## IMPORTANT PRODUCT INFORMATION

**Product:**     **IC693DSM302 Module (“DSM302”)**  
                  IC693DSM302AD  
                  Firmware Version 1.30

## Purpose of this Document

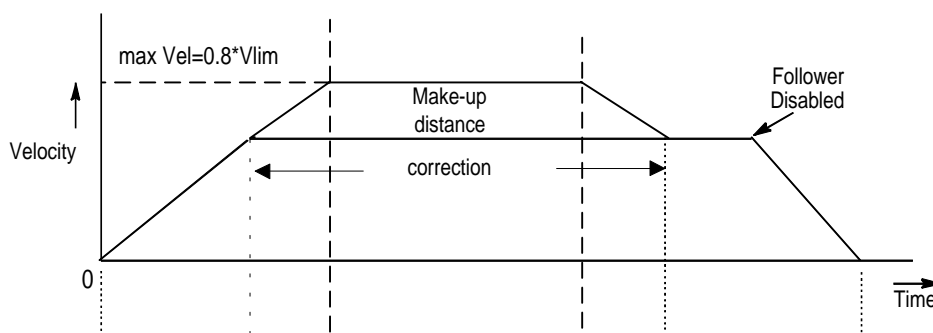
The Follower Axis Ramp Control Function is enhanced in DSM firmware release 1.30. The enhancement improves motion smoothness. Prior to this release, when the follower was active and the master in motion, the acceleration/deceleration control during the make-up correction phase was not controlled by a velocity profile. This could cause unwanted machine shock. The enhanced method uses a trapezoidal velocity profile to address this problem. During the entire make-up correction phase, the acceleration/deceleration is limited to the jog acceleration value. Also during the correction, the velocity is not allowed to exceed the maximum. Appropriate warning/error codes notify the user about abnormal operation (see error table below).

The figure below shows the velocity profile during the follower ramp cycle. *Note: The enhanced follower make-up may affect existing applications that use the old follower make-up feature.*
